TRAFFIC NOISE ANALYSIS
I-39, US 20, and Harrison Avenue
Reconstruction
Winnebago County, Illinois

Revised February 2023

ADDENDUM TO TRAFFIC NOISE ANALYSIS REPORT

I-39, US 20, AND HARRISON AVENUE RECONSTRUCTION
WINNEBAGO COUNTY, ILLINOIS
SECTIONS (201-3)L & (4-1,5)R

**Barrier 8-10, 21
Alternate Alignment**

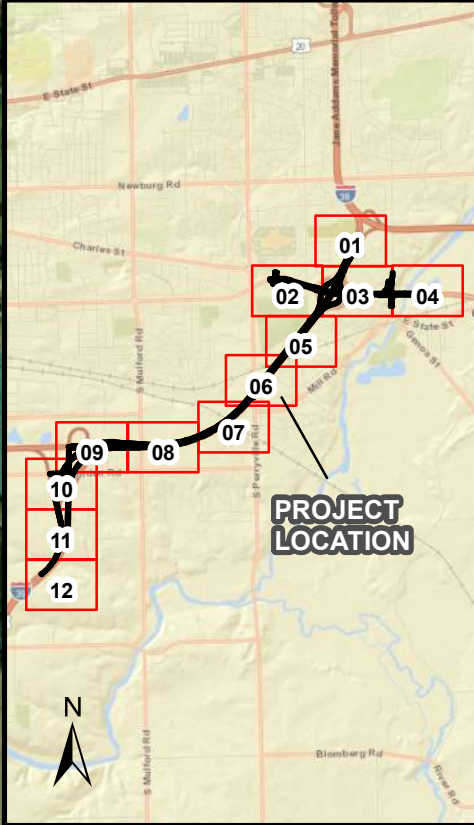
Barrier 8-10, 21: Incorporating the design updates to Perryville Road, two revised alignments and base profiles of Barrier 8-10, 21 were analyzed. One of the revised alignments omits the portion of the barrier parallel to Perryville Road present in the original analysis. Iterations of each with wall heights varying between 12 and 14 feet were included in the analysis. Heights outside of this range reflected higher cost-benefits and were subsequently omitted from the results.

The most cost-effective barrier design identified is a 5,809-foot continuous wall with a constant height of 13 feet. It achieves 5 receptors meeting the design goal reduction, benefits 83 receptors, and its cost per benefited receptor is \$27,295. This barrier is shorter in length, benefits more receptors, and achieves a more economical cost per benefited receptor than its predecessor. Its alignment is continuous and does not include the portion parallel to Perryville Road. The original version of Barrier 8-10, 21 had a length of 6,482 feet including the portion parallel to Perryville Road, benefited 82 receptors, and cost \$30,829 per benefited receptor. A map of this revised alignment is attached for reference.
